**Re: West Elbow Communities Local Area Plan (WEC-LAP) Bylaw
Public Hearing – Tuesday May 6, 2025**

Re: **Feedback on West Elbow Communities Local Area Plan Draft Chapter 2**

**Collective Proposed Amendments
to the
West Elbow Local Area Plan
May 1, 2025**

Figure 3: Existing & Potential
Areas for Growth Map

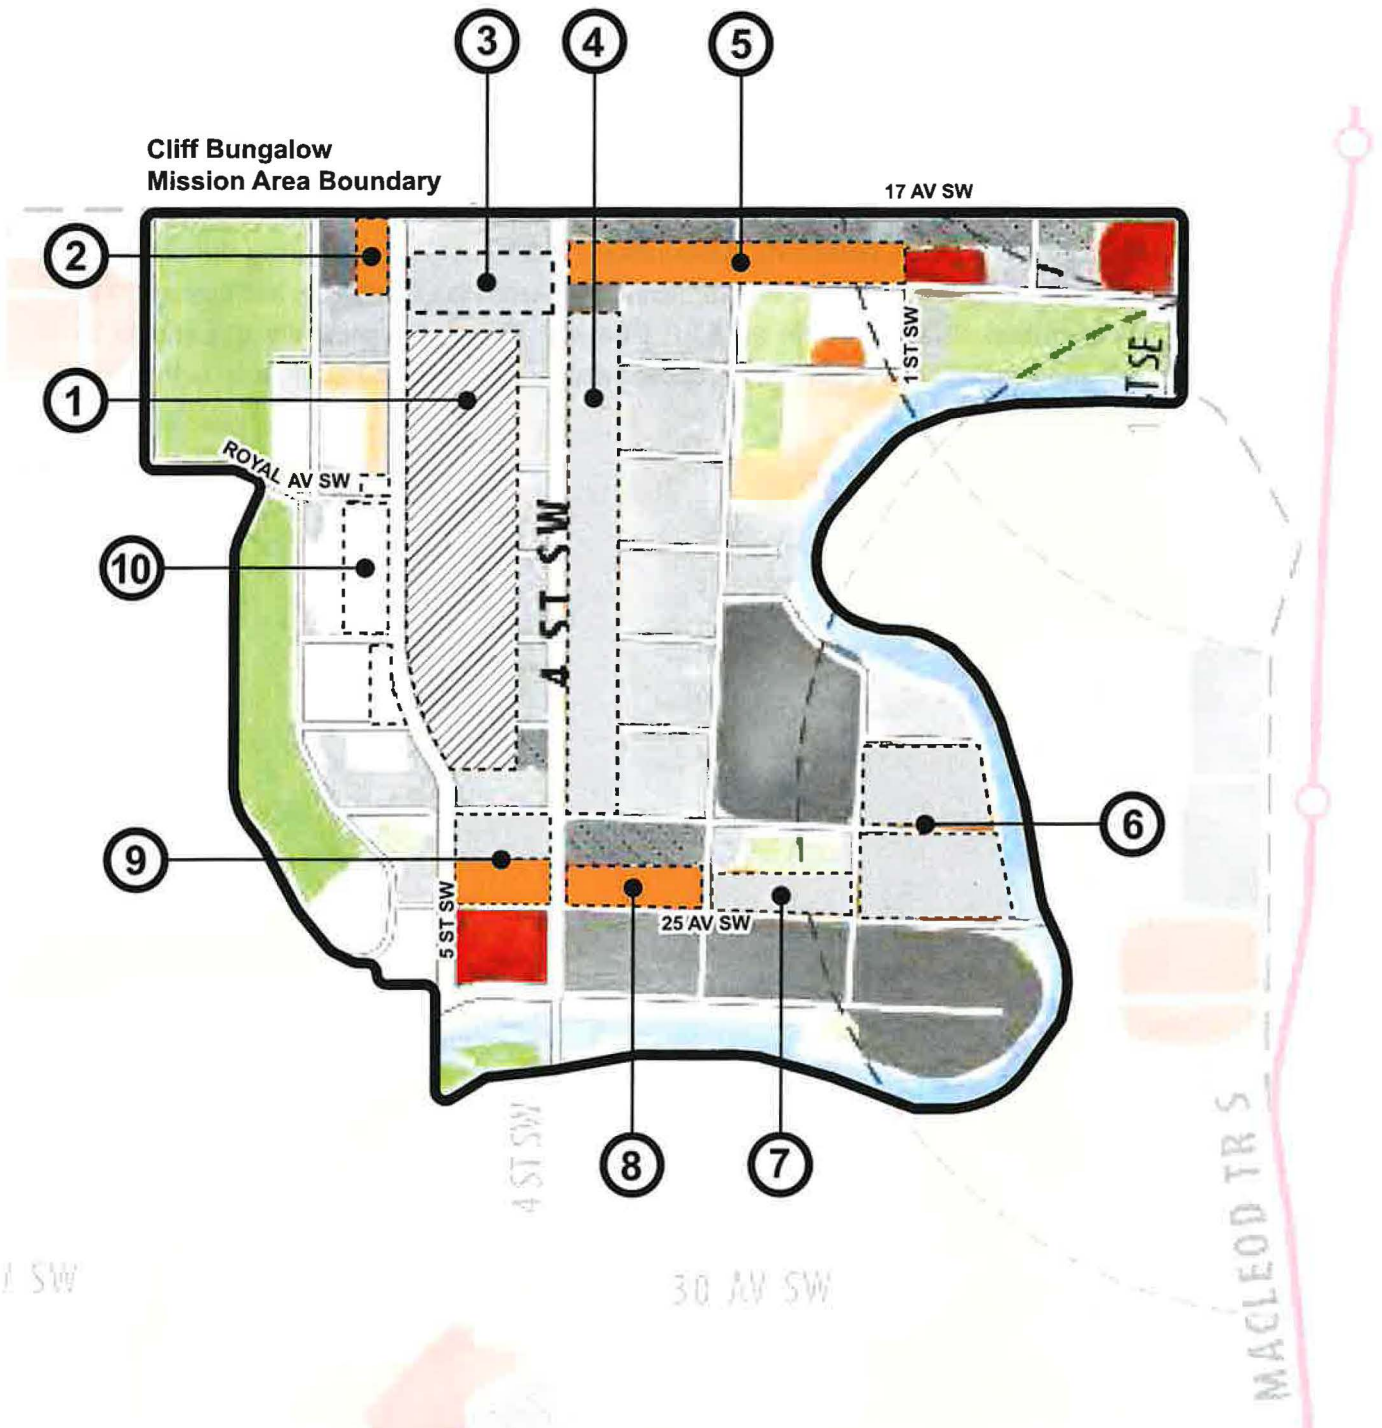
Item 1. Disagree with proposed change. CBMCA suggests leaving this area as a mix of white and grey.

Item 3. Disagree with proposed change. CBMCA suggests leaving this grey.

Item 4. Disagree with proposed changes. CBMCA suggests leaving this grey.

6. Disagree – CBMCA suggests leaving this grey.

9. Directionally agree with increasing allowable height, but disagree with proposed scale to some extent. CBMCA suggest changing this to Orange instead of Red.

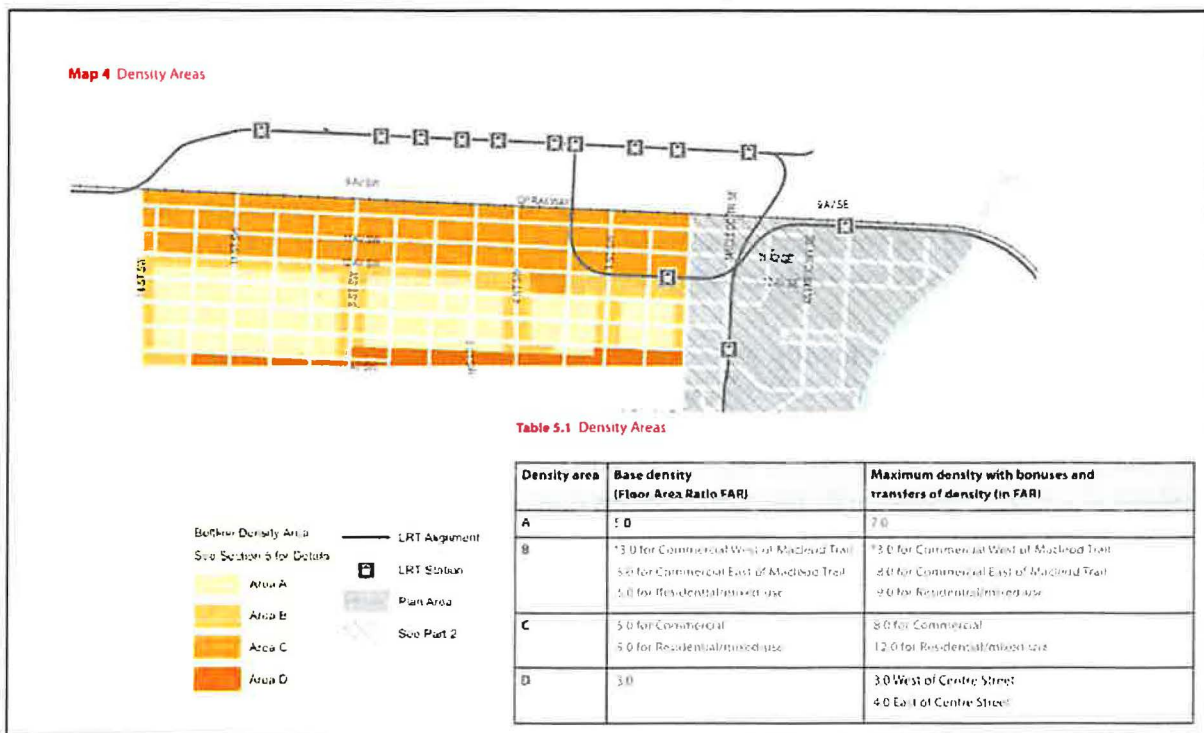
Exhibit 1. ASI's Arlington Street Project has a mixed-use component along 17 Avenue SW of ~3.0x and a multifamily component of 8.0x, which the total project exceeding 6.0x FAR. This is too much massing and height for a transitional zone between 5.0x and 3.0x.

The CBMCA position for ASI's LOC Application was that an 8-10 storey tower was more appropriate than a 16-storey tower as it allowed for a transition between the maximum 5-storey buildings within the core of Cliff Bungalow and typical 10-15 storey-developments within the Beltline that are achievable with an FAR of 5.0x-7.0x. The idea of transitioning from a 10-15 storey (FAR 5.0x-7.0x) development in the Beltline to a 16-storey tower in Cliff Bungalow (7.5x-8.5x FAR) and then to 4-6 storey developments (~1.5x-3.0x) within the core of Cliff Bungalow is nonsensical. However, the LOC Application process does not allow for such nuance because City Council is ultimately presented with two choices (existing vs proposed) rather than a discussion of what is optimal. A reasonable "transitional area" between the FAR of 5.0x-7.0x allowed in the Beltline and 1.5x-3x in the core of Cliff Bungalow would be an area of 3.5x-4.5x FAR which would translate to a 7-12 storey development.

Exhibit 3. A laneway between the 17th Avenue and 18th Avenue makes projects such as ASI's Arlington project unviable for this block. There is also agreement that the west side of 4th Street should remain within 4-6 storey guardrails to minimize shadowing.

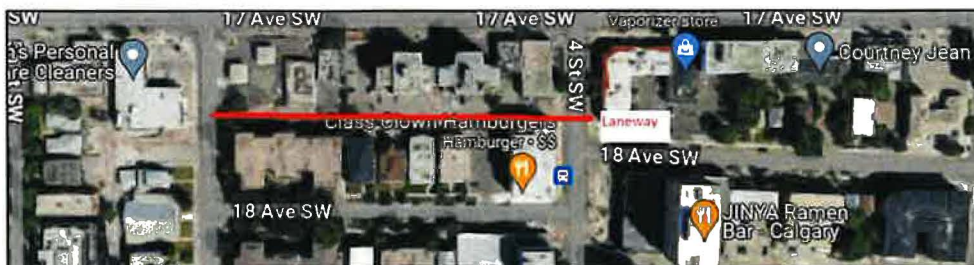
One rationale of upzoning the parcels along 17 Avenue SW between 5 Street SW and 5A Street SW is that the lack of a laneway allowed for a five-storey mixed-use podium along 17 Avenue SW with taller tower component at the south end of the podium. Allowing for a taller tower provided the developer with a higher budget to pursue higher quality architectural designs and façade materials.

However, between 4th Street SW and 5th Street SW, a laneway runs between 17th Avenue and 18th Avenue. This makes the same strategy unviable for this block. As such, the appropriate zoning would be to keep building heights at 4-6 storey along the north side of 18 Avenue for this block (uniform with the buildings further south). The CBMCA would be open to supporting a 7-12 storey building if a developer was able to consolidate buildings on both sides of the block (similar to Hines One Park Central in the Beltline).

Exhibit 7. Transitional area between 15-storey buildings and 5 storey buildings

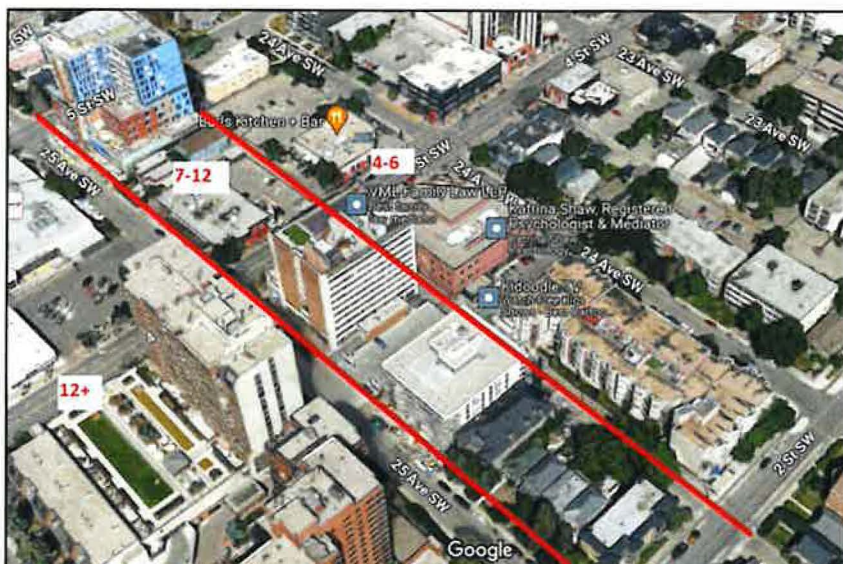
The buildings along 26 Avenue SW and the south side of 25 Avenue SW allow for a maximum 15-storey height. It is the CBMCA's understanding that the City of Calgary is strongly advocating to keep this height limit in place for the newest proposed development within this area.

As such, a transitional area between the 15-storey buildings to the south of 25 Avenue and 5-storey buildings to the north would allow for 7-12 storeys, which is Orange. Additionally, note that parcels to the north of this area are incorrectly shaded. The correct shading is light grey, corresponding to 4-6 storey developments.

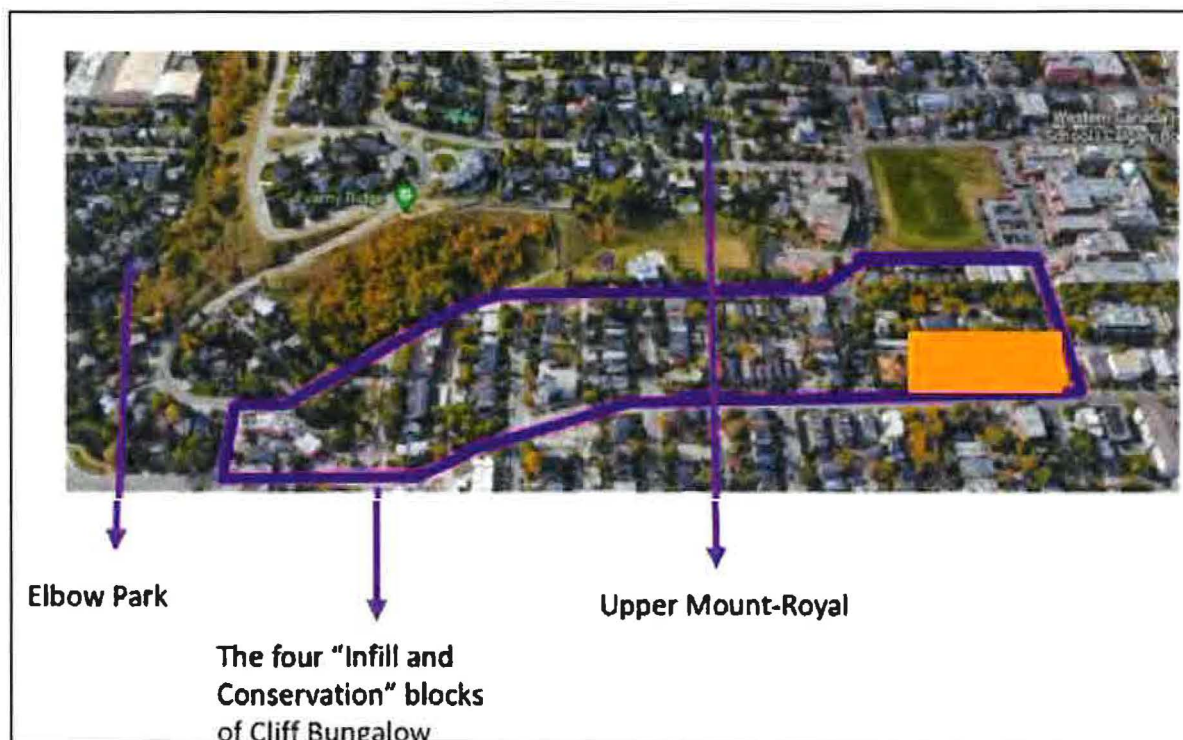
The “Conservation and Infill” Policy Area consists primarily of low-density residential structures, and thus allows for the development of single-detached, semi-detached and townhouse dwellings (both row-townhouses and courtyard style townhouses). As shown in the map below, this remains contextually appropriate in part because the “Conservation and Infill” Policy Area of Cliff Bungalow is contiguously bounded by the low-density residential areas of Elbow Park (and Rideau

and Roxboro) to the South and Upper Mount Royal to the West. The CBMCA believes these four blocks of primarily low-density, residential dwellings should thus be viewed as an extension of these low-density neighborhoods. As such, the “Conservation and Infill” Policy Area should be treated in-line with City Administration’s vision for other low-density residential areas within the inner-city, allowing for single-family homes, semi-detached dwellings and townhouses.

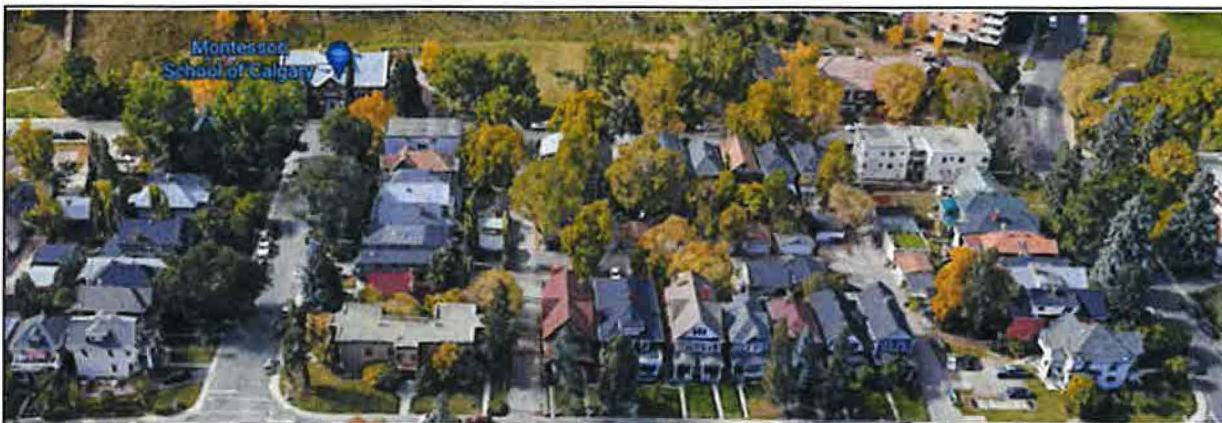
The “Conservation and Infill” Policy Area largely consists of heritage homes and heritage apartment buildings, largely built between 1910-1920. Given that the “Conservation and Infill” Policy Area has been in existence for at least 35-years, it should be no surprise that it has attracted civic-minded homeowners and multi-family investors to the area that have used private capital to purchase, restore and steward their heritage homes and heritage apartments, furthering the MDP objective of historical preservation. As a result, the large majority of the block-faces within Cliff Bungalow’s “Conservation and Infill” Policy Area, fully meet the eligibility criteria for inclusion into the City of Calgary’s established “Heritage Area” framework.

Figure 3: Existing & Potential
Areas for Growth Map

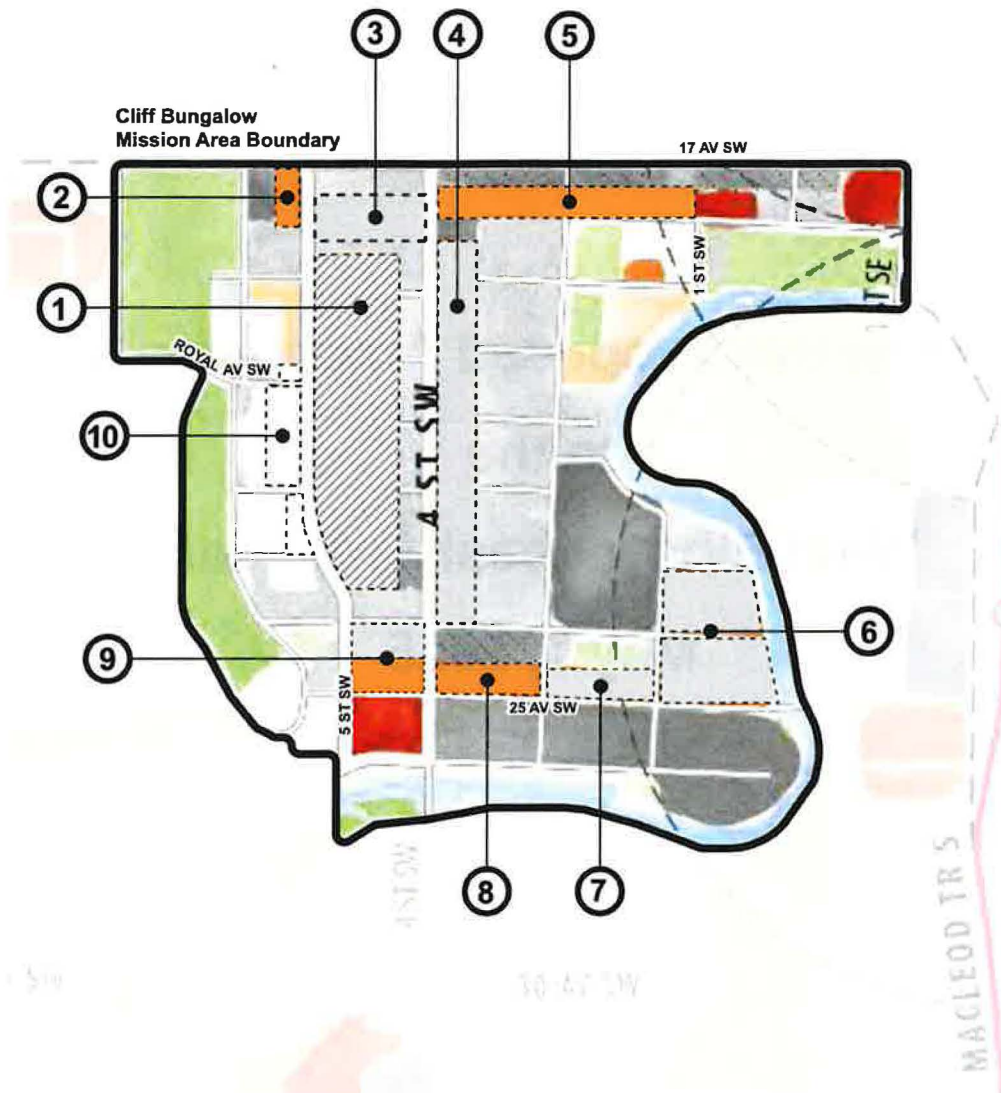
Item 1. Disagree with proposed change. CBMCA suggests leaving this area as a mix of white and grey.

Item 3. Disagree with proposed change. CBMCA suggests leaving this grey.

Item 4. Disagree with proposed changes. CBMCA suggests leaving this grey.

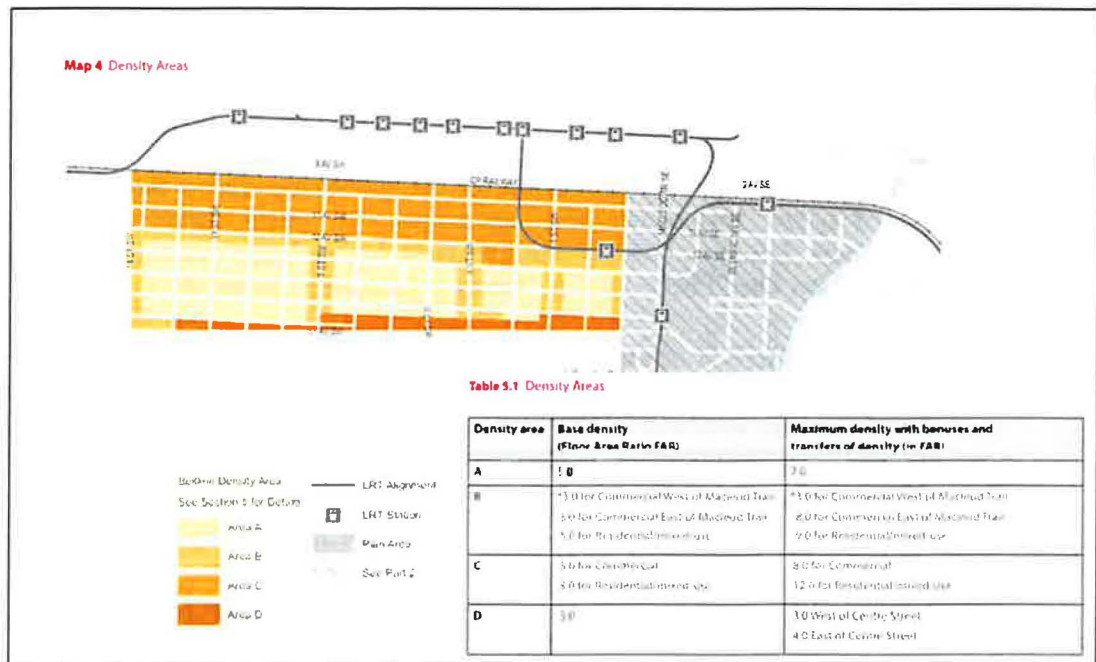
Exhibit 1. ASI's Arlington Street Project has a mixed-use component along 17 Avenue SW of ~3.0x and a multifamily component of 8.0x, which the total project exceeding 6.0x FAR. This is too much massing and height for a transitional zone between 5.0x and 3.0x.

The CBMCA position for ASI's LOC Application was that an 8-10 storey tower was more appropriate than a 16-storey tower as it allowed for a transition between the maximum 5-storey buildings within the core of Cliff Bungalow and typical 10-15 storey-developments within the Beltline that are achievable with an FAR of 5.0x-7.0x. The idea of transitioning from a 10-15 storey (FAR 5.0x-7.0x) development in the Beltline to a 16-storey tower in Cliff Bungalow (7.5x-8.5x FAR) and then to 4-6 storey developments (~1.5x-3.0x) within the core of Cliff Bungalow is nonsensical. However, the LOC Application process does not allow for such nuance because City Council is ultimately presented with two choices (existing vs proposed) rather than a discussion of what is optimal. A reasonable "transitional area" between the FAR of 5.0x-7.0x allowed in the Beltline and 1.5x-3x in the core of Cliff Bungalow would be an area of 3.5x-4.5x FAR which would translate to a 7-12 storey development.

Exhibit 3. A laneway between the 17th Avenue and 18th Avenue makes projects such as ASI's Arlington project unviable for this block. There is also agreement that the west side of 4th Street should remain within 4-6 storey guardrails to minimize shadowing.

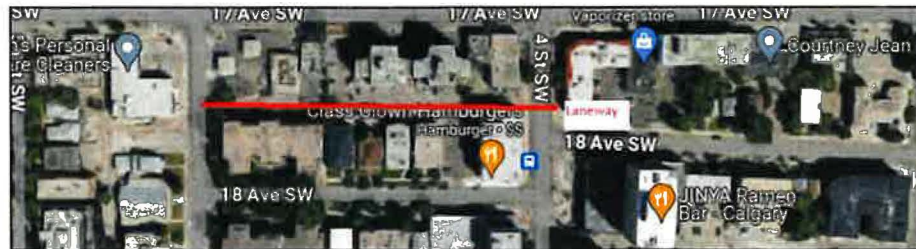
One rationale of upzoning the parcels along 17 Avenue SW between 5 Street SW and 5A Street SW is that the lack of a laneway allowed for a five-storey mixed-use podium along 17 Avenue SW with taller tower component at the south end of the podium. Allowing for a taller tower provided the developer with a higher budget to pursue higher quality architectural designs and façade materials.

However, between 4th Street SW and 5th Street SW, a laneway runs between 17th Avenue and 18th Avenue. This makes the same strategy unviable for this block. As such, the appropriate zoning would be to keep building heights at 4-6 storey along the north side of 18 Avenue for this block (uniform with the buildings further south). The CBMCA would be open to supporting a 7-12 storey building if a developer was able to consolidate buildings on both sides of the block (similar to Hines One Park Central in the Beltline).

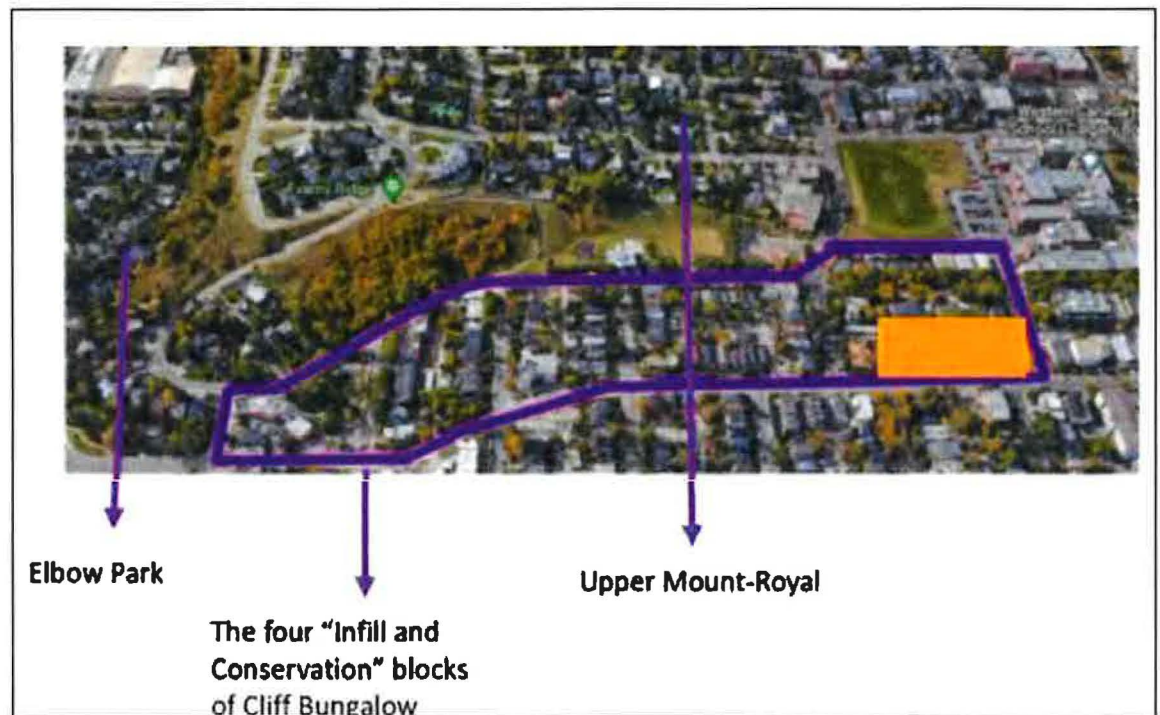
The “Conservation and Infill” Policy Area consists primarily of low-density residential structures, and thus allows for the development of single-detached, semi-detached and townhouse dwellings (both row-townhouses and courtyard style townhouses). As shown in the map below, this remains contextually appropriate in part because the “Conservation and Infill” Policy Area of Cliff Bungalow is contiguously bounded by the low-density residential areas of Elbow Park (and Rideau

and Roxboro) to the South and Upper Mount Royal to the West. The CBMCA believes these four blocks of primarily low-density, residential dwellings should thus be viewed as an extension of these low-density neighborhoods. As such, the “Conservation and Infill” Policy Area should be treated in-line with City Administration’s vision for other low-density residential areas within the inner-city, allowing for single-family homes, semi-detached dwellings and townhouses.

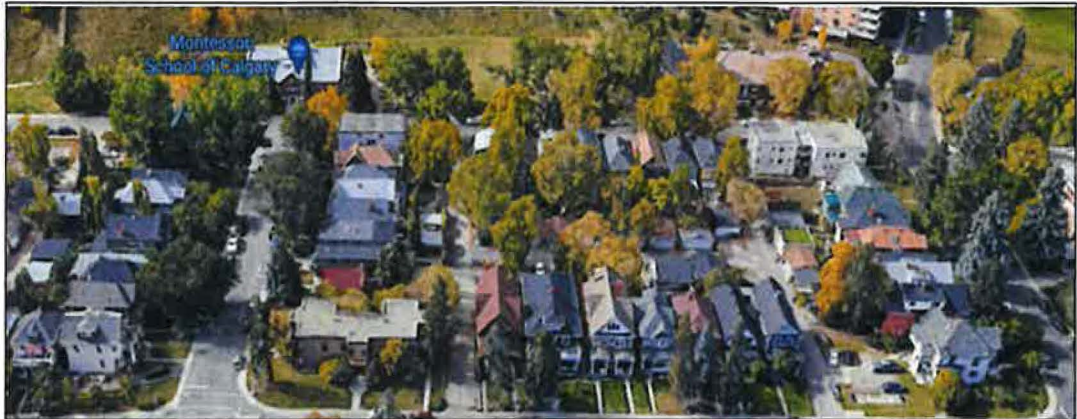
The “Conservation and Infill” Policy Area largely consists of heritage homes and heritage apartment buildings, largely built between 1910-1920. Given that the “Conservation and Infill” Policy Area has been in existence for at least 35-years, it should be no surprise that it has attracted civic-minded homeowners and multi-family investors to the area that have used private capital to purchase, restore and steward their heritage homes and heritage apartments, furthering the MDP objective of historical preservation. As a result, the large majority of the block-faces within Cliff Bungalow’s “Conservation and Infill” Policy Area, fully meet the eligibility criteria for inclusion into the City of Calgary’s established “Heritage Area” framework.
